| ROADWAY PLAN                                                         |                                                    |
| INTERSTATE ROUTE H-1 RESURFACING                                     |                                                    |
| Miller Pedestrian Overpass to Kapiolani Interchange                  |                                                    |
| Federal-Aid Project No. NH-HI-1(279)                                 |                                                    |

| SHEET No. R8 OF 41 SHEETS                                                                                                       |   |                                                                                                     |

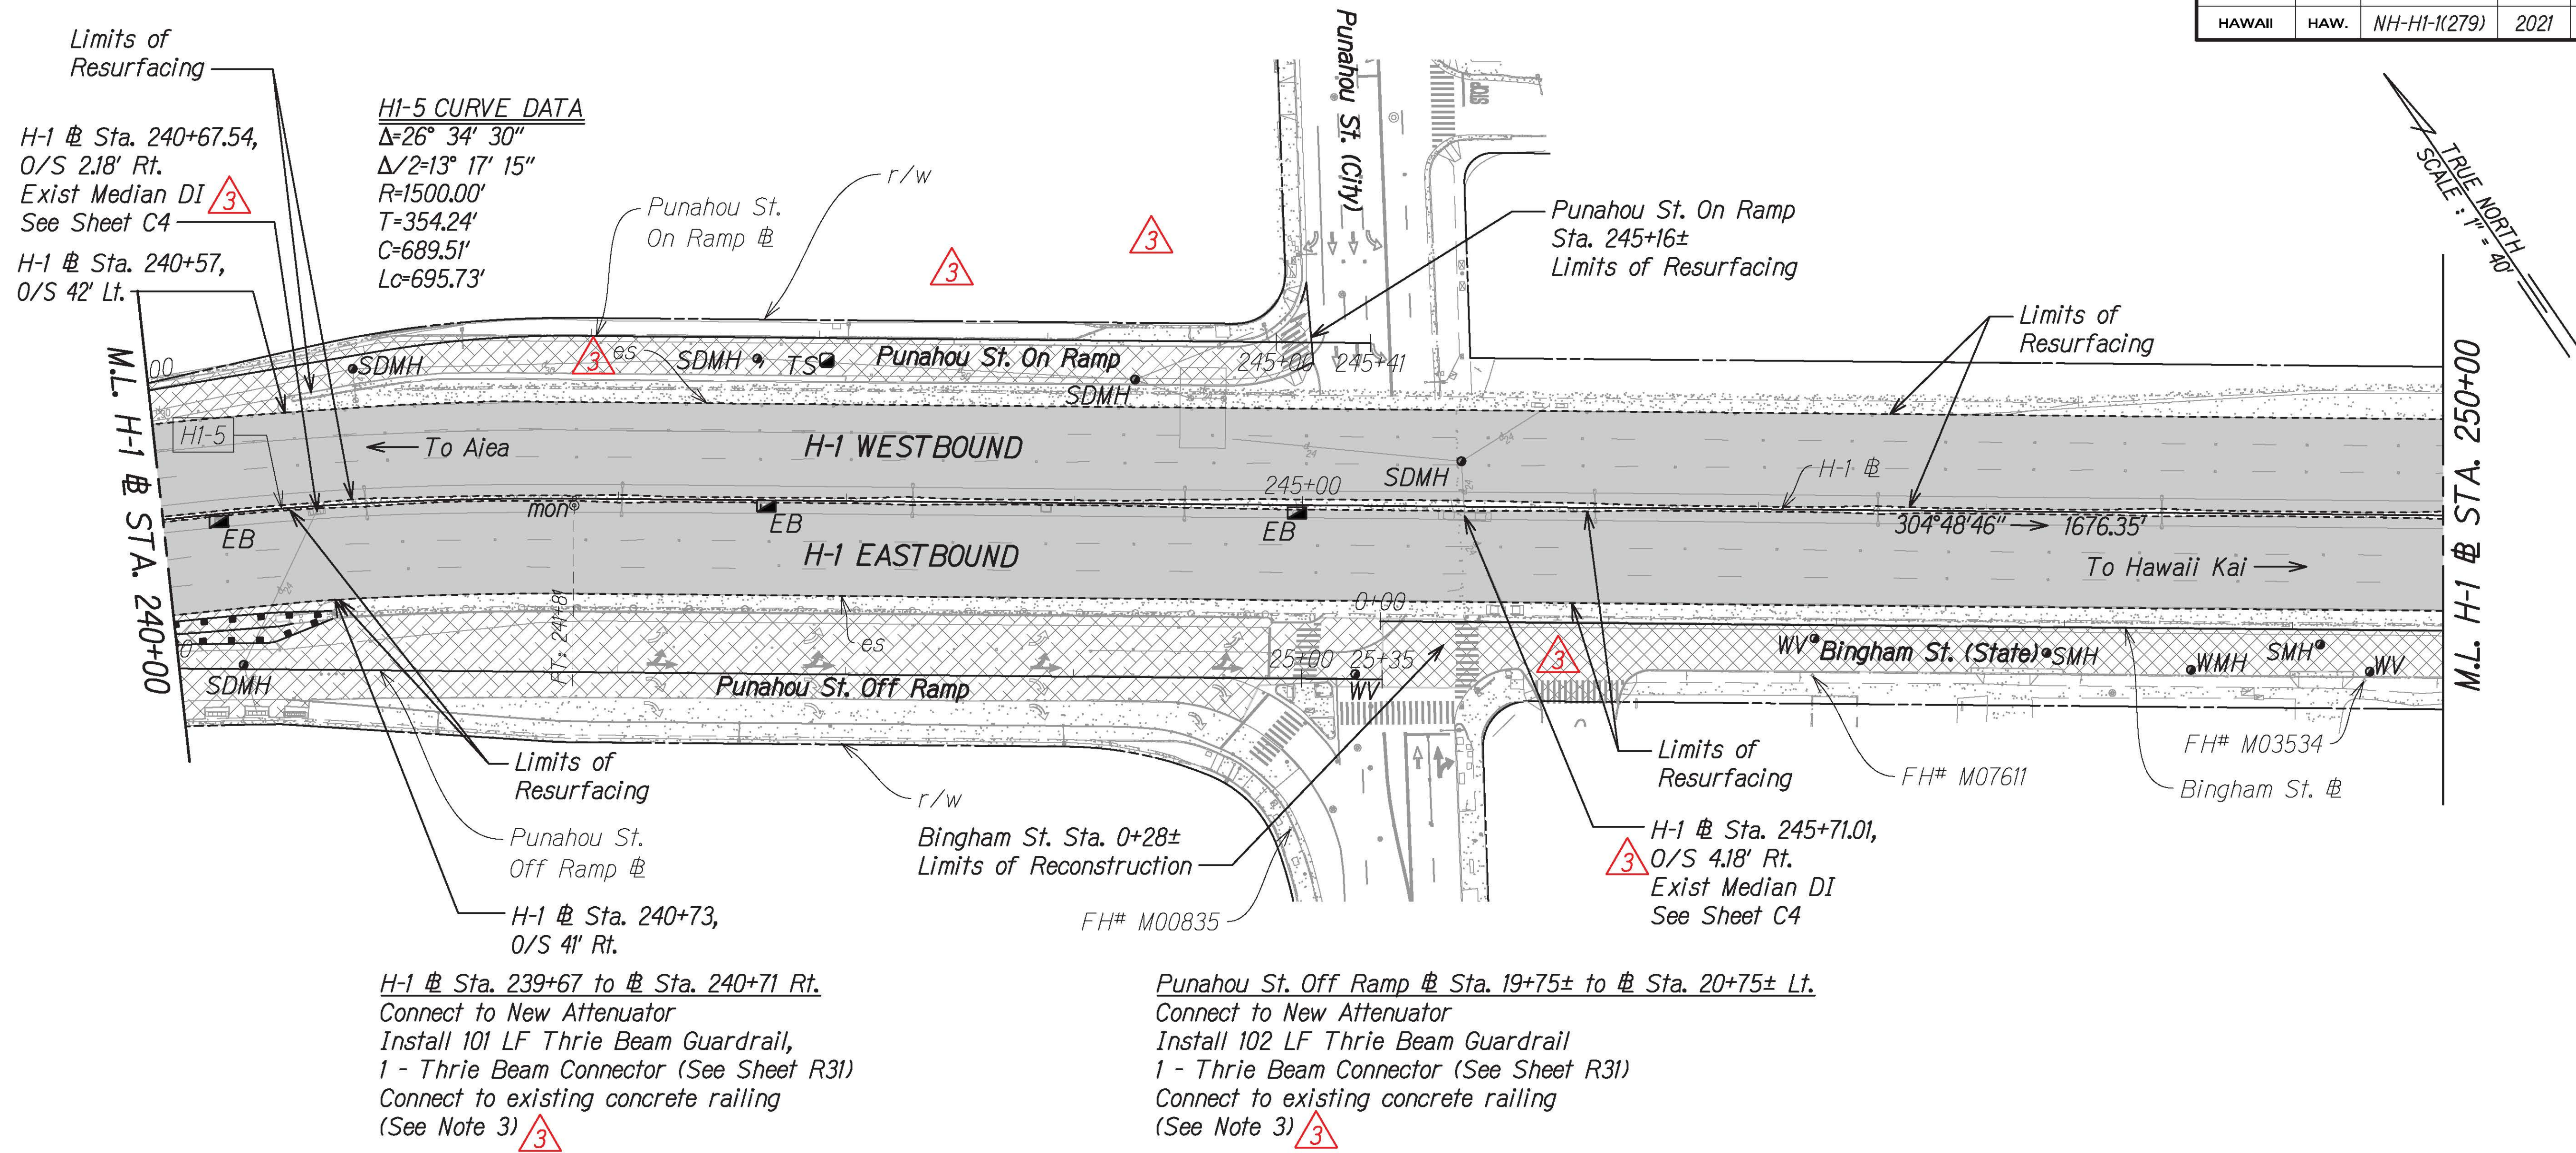
| 7/9/21                                                                                                                          | 3 | BWS Tracings, Revised Guardrails Resurfacing Limits and Pav't Section, Added Exist. Median DI label |

| SHEET No. R9 OF 41 SHEETS                                            |                                           |

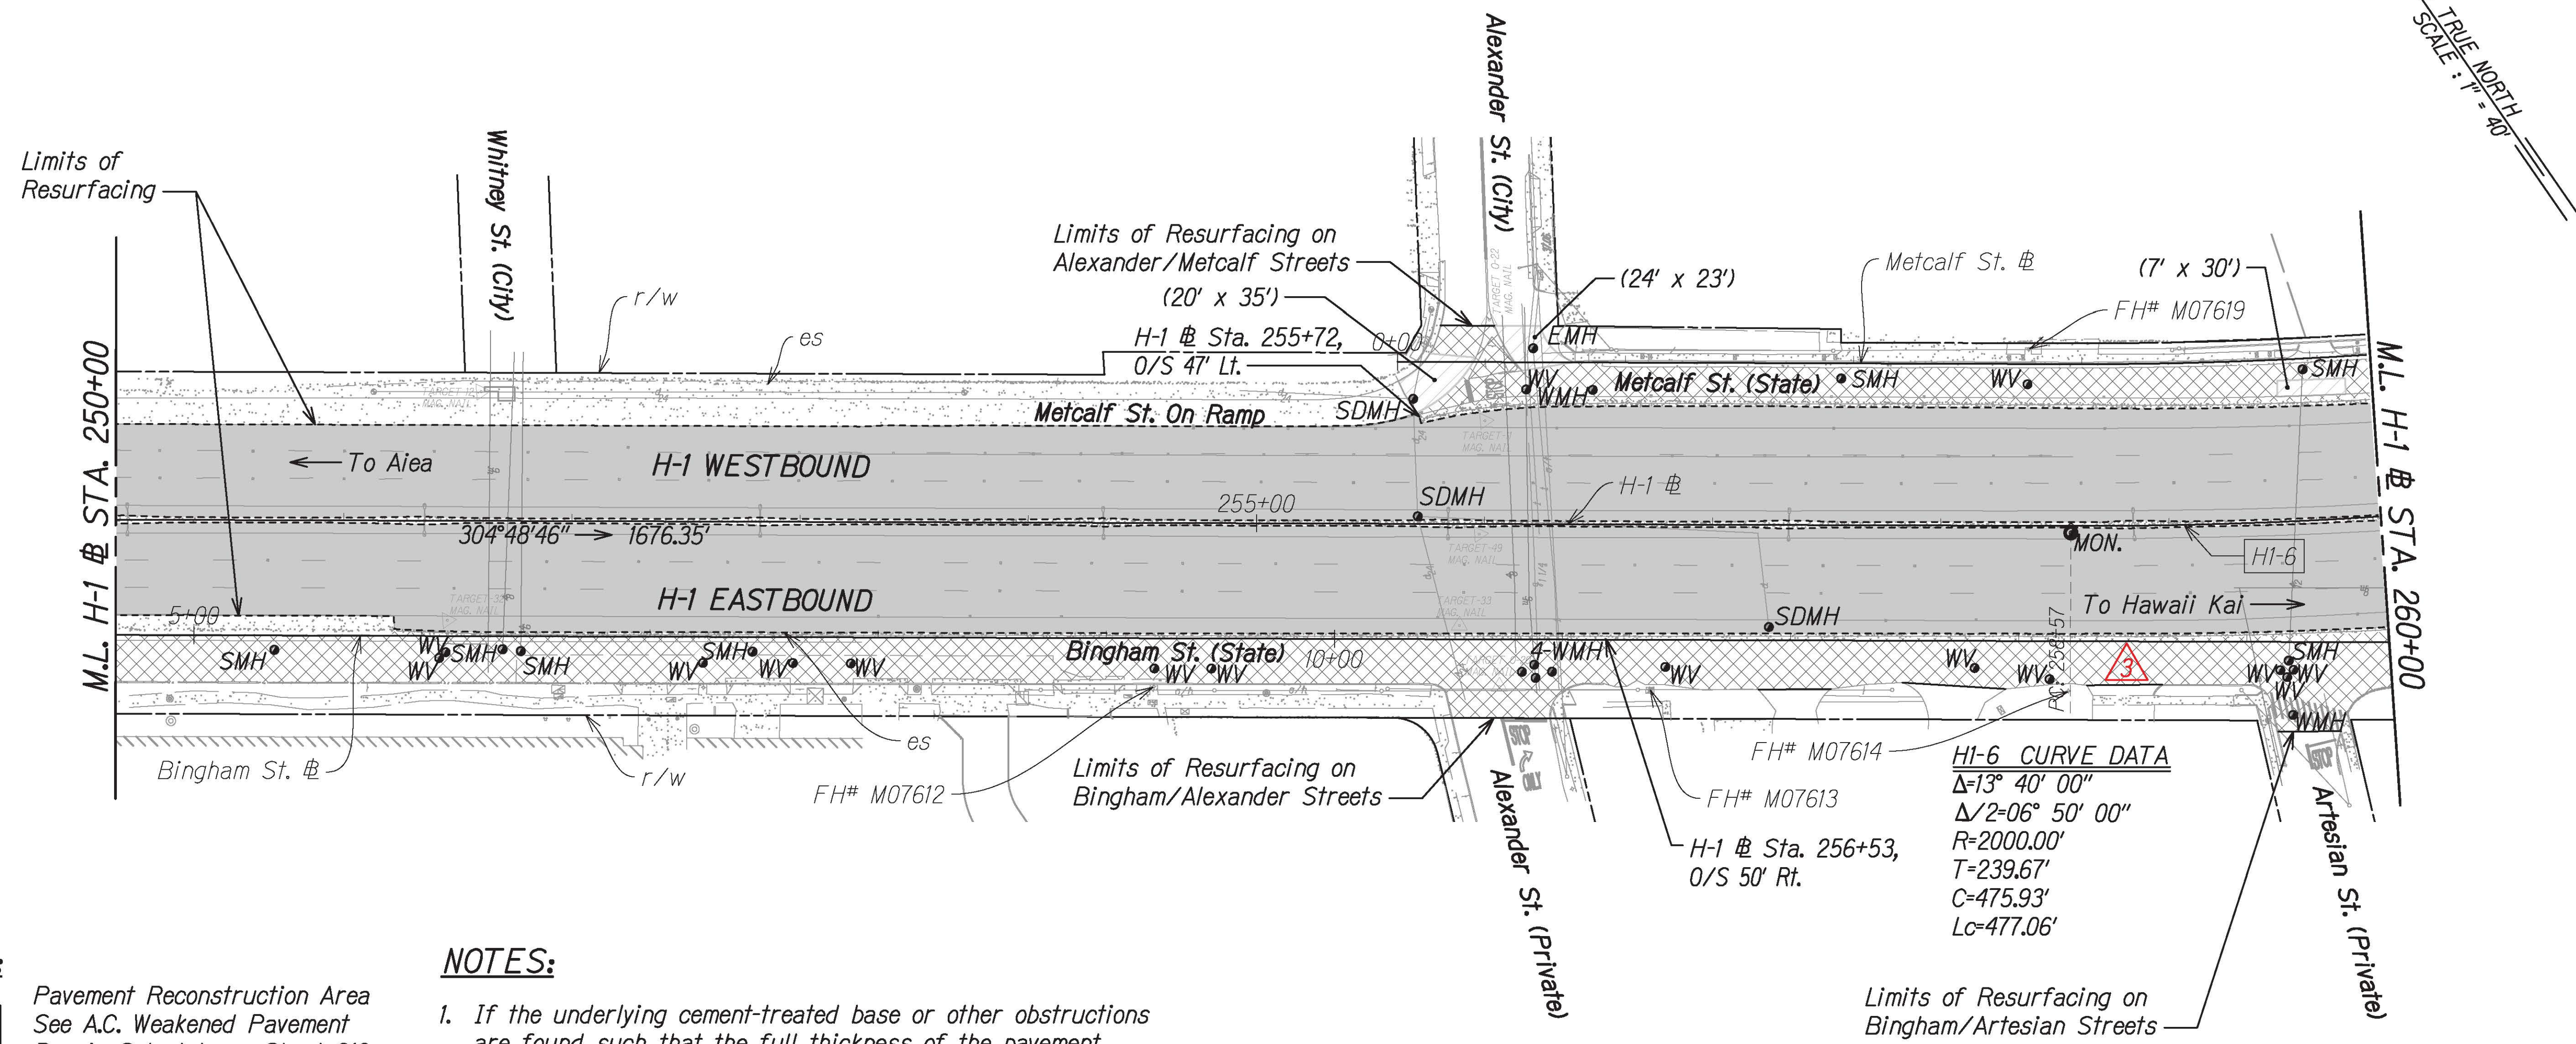
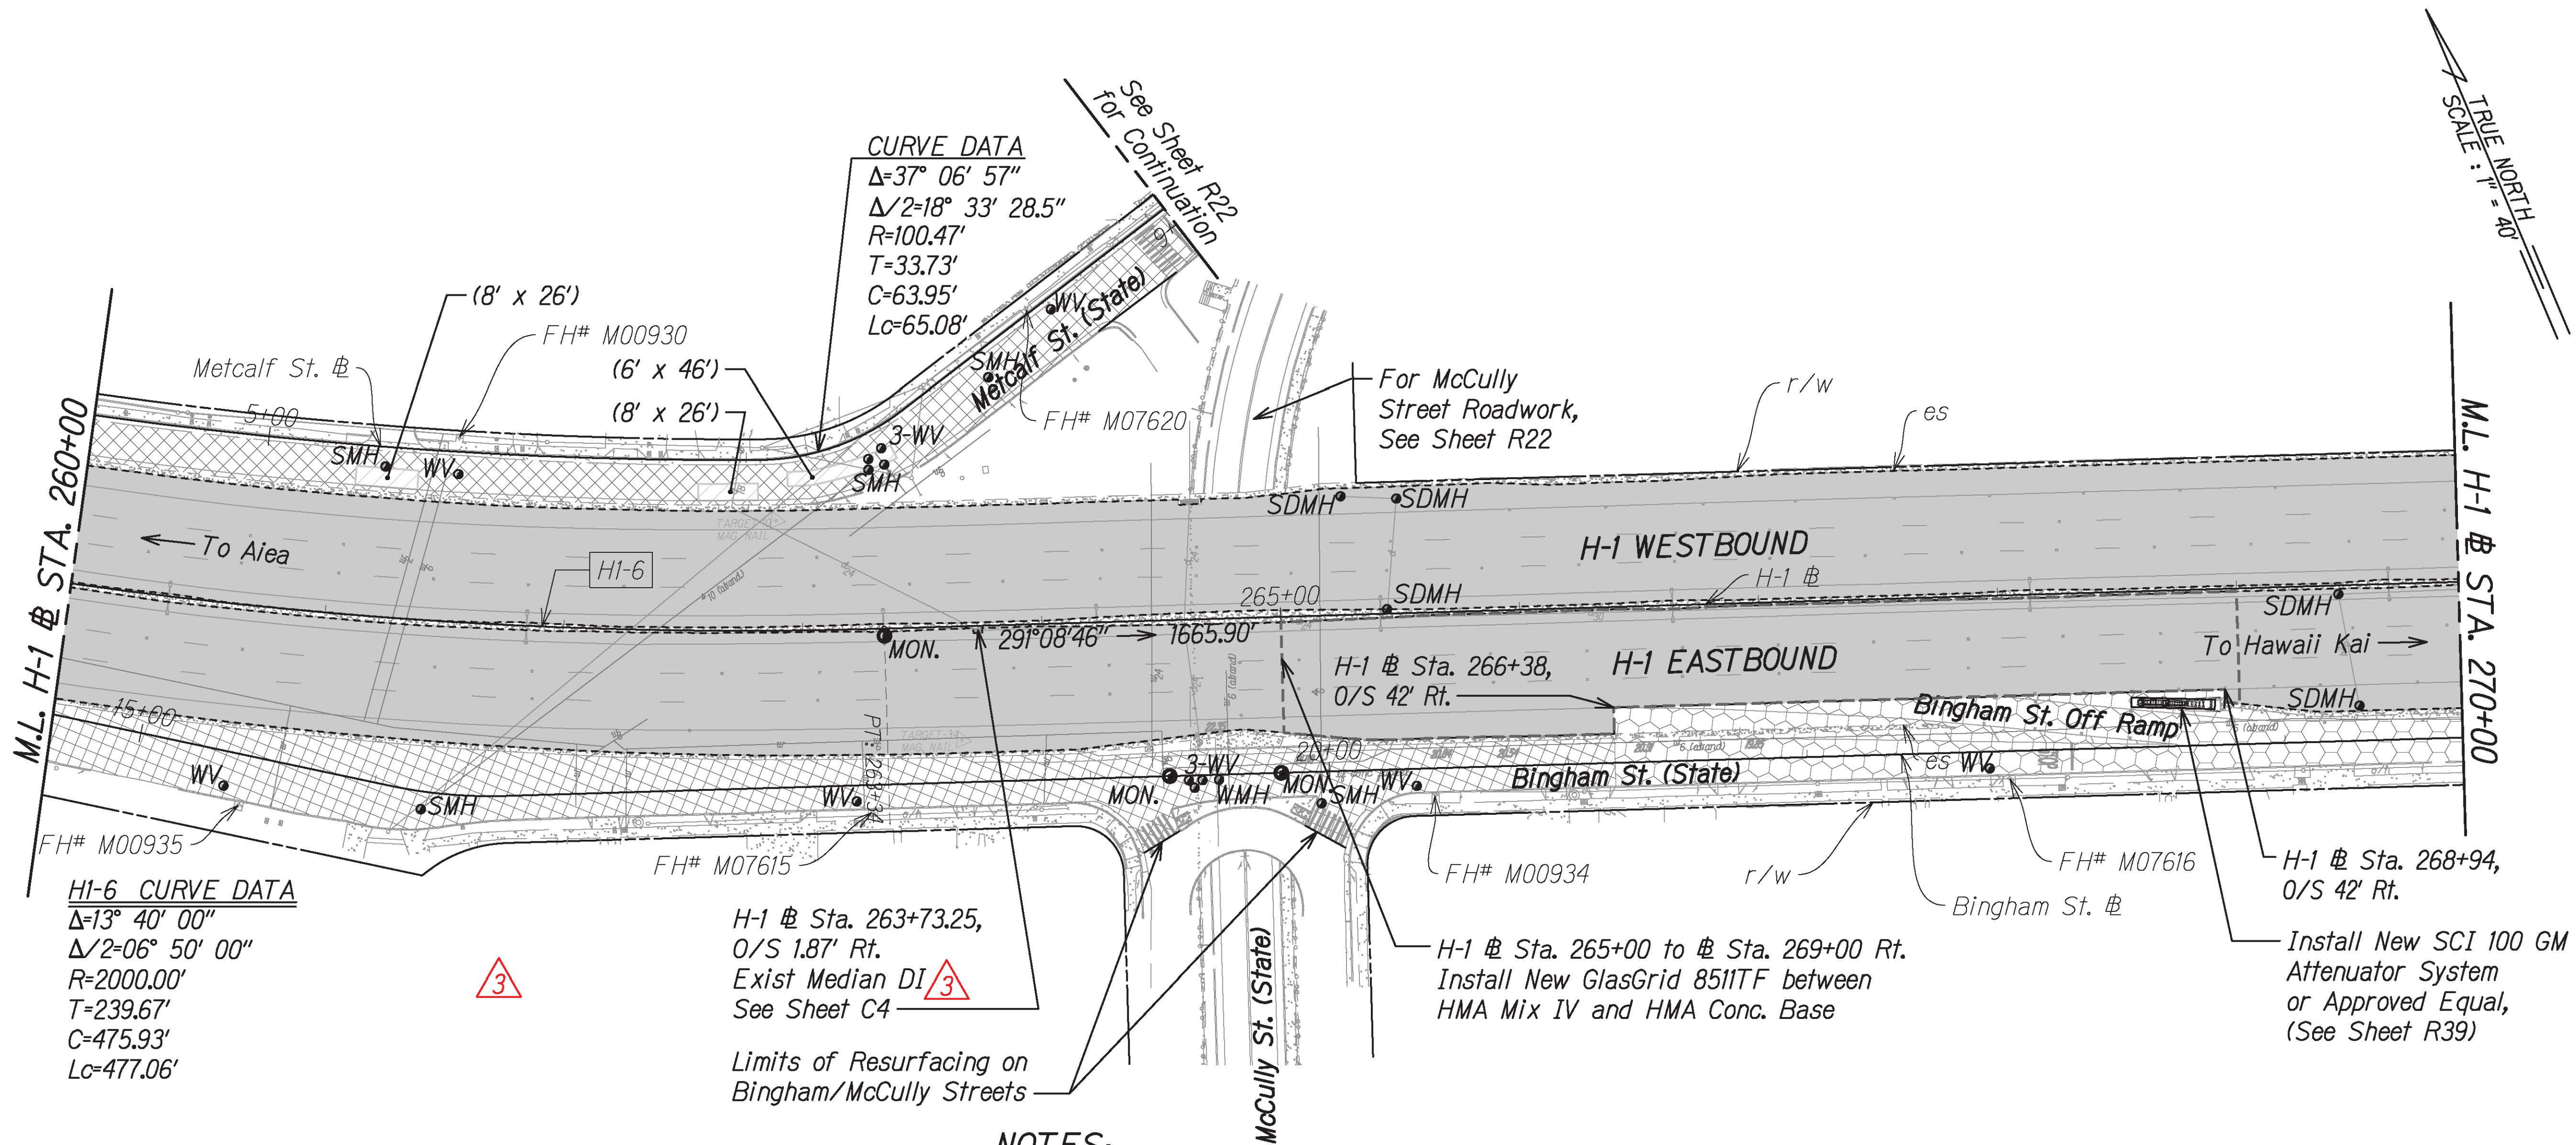
| 7/9/21                                                               | BWS Tracings and Revised Pavement Section |

| SHEET No. R11 OF 41 SHEETS                                           |          |                                                                         |

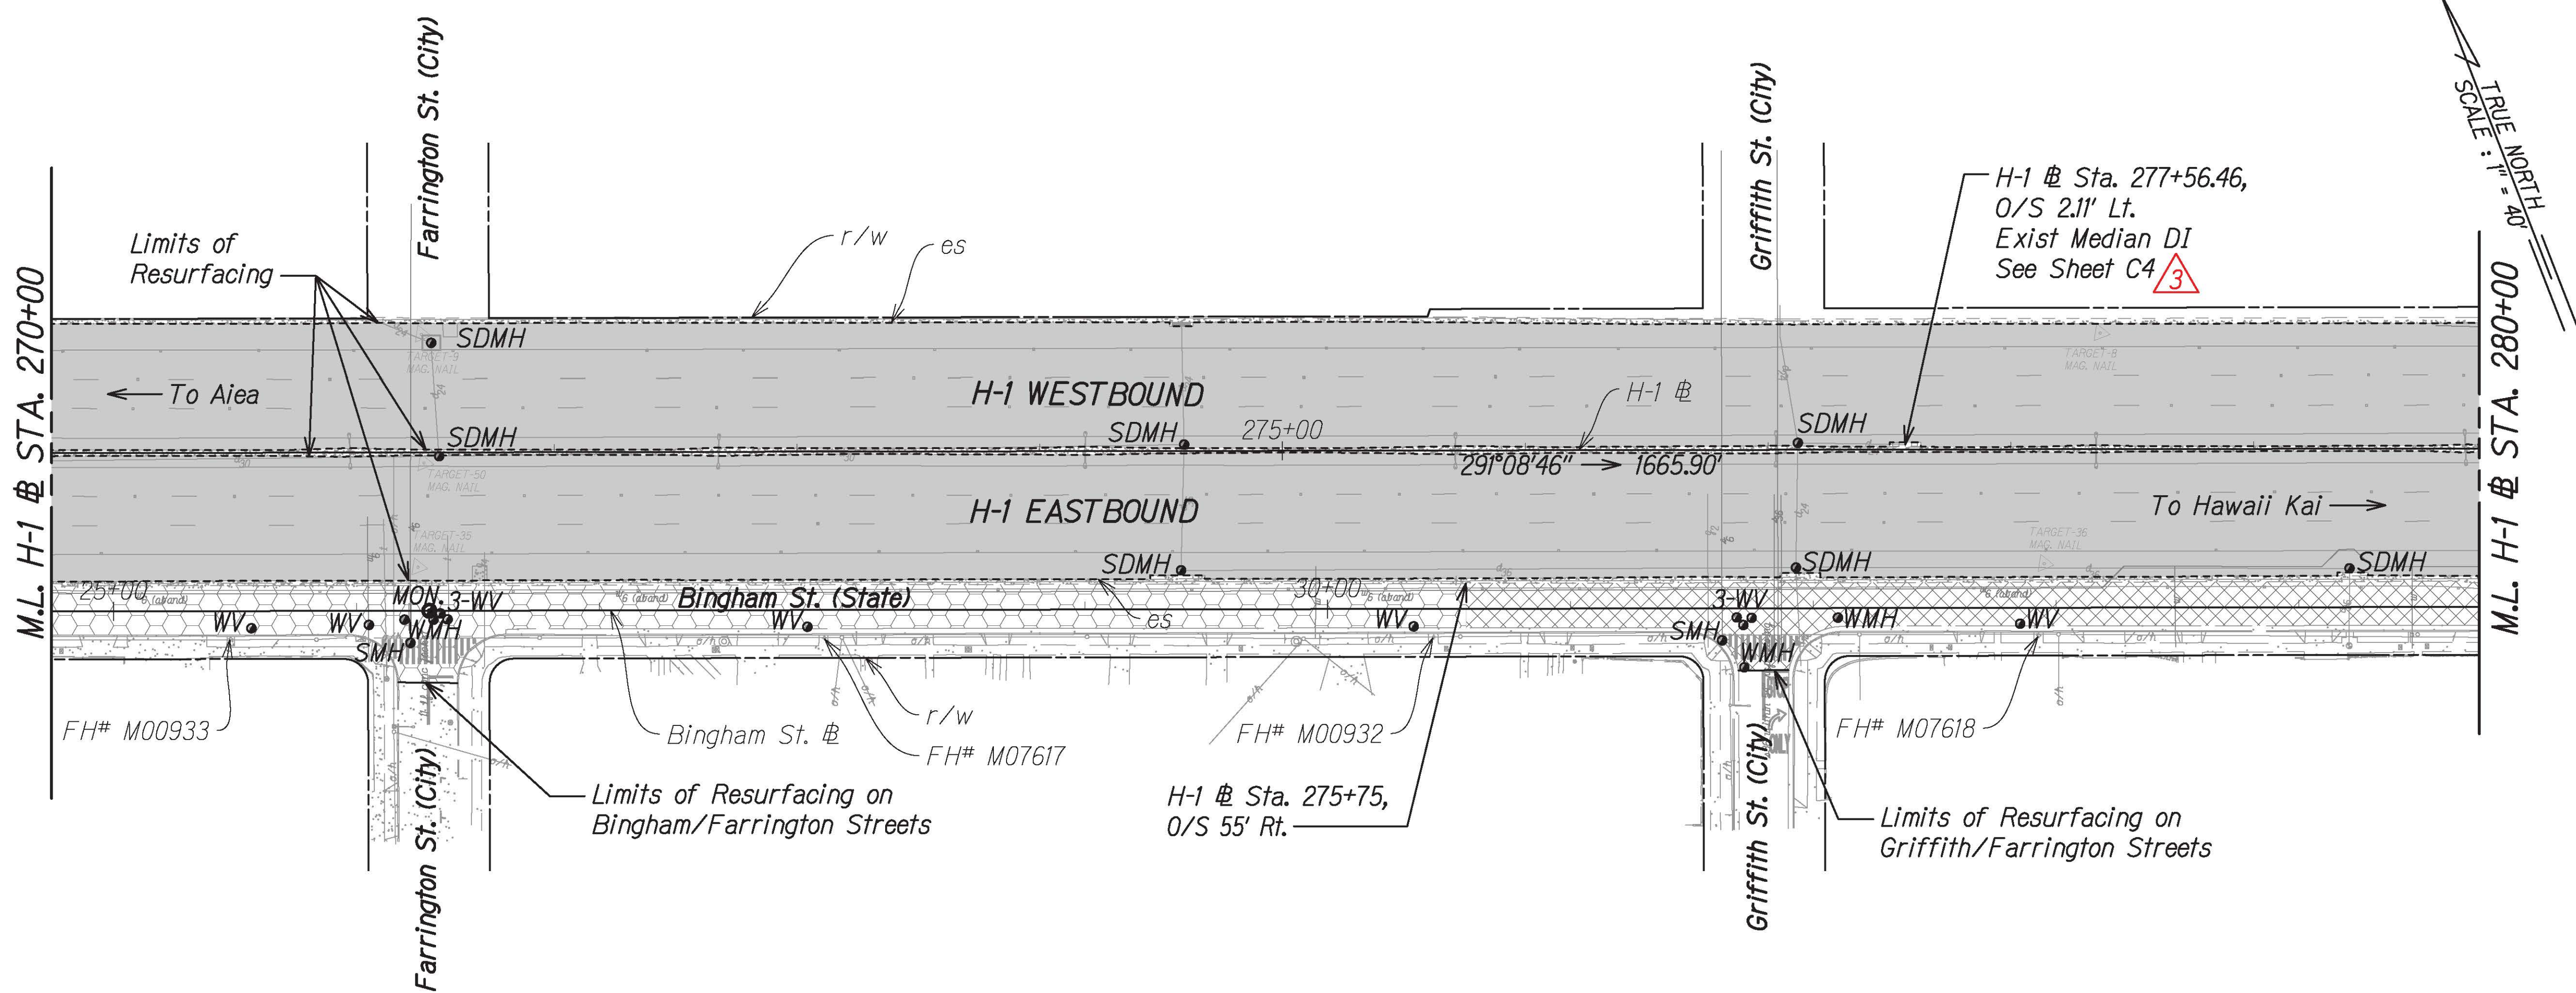
| 7/9/21                                                               | 3        | BWS Tracings and Revised Pavement Section, Added Exist. Median DI label |
